Our Ref
 CRTR-PLAN-2021-31975

Proposal: Prior Extraction of Sand / Gravel and Subsequent Restoration with Inert Engineering Fill to Facilitate a Platform for Employment Development, or Agriculture, with Peripheral Landscaping.

# Location: Land North of A674, Millenium Way Northeast of M61 Junction 8,

Waterway: Leeds & Liverpool Canal

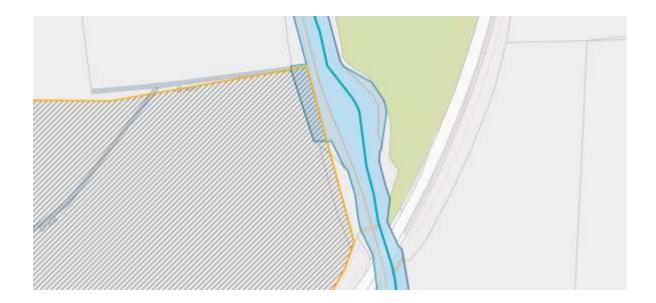
Based on the red line of the application site it appear to include a section of land on the canal cutting which is within the ownership of the Canal & River Trust. Notice has not been served on the Trust. We would ask that the red line of the application site is amended to remove the land within our ownership as shown on the plan below. The blue area is the land within the ownership of the Trust, with the orange line being the application site superimposed.
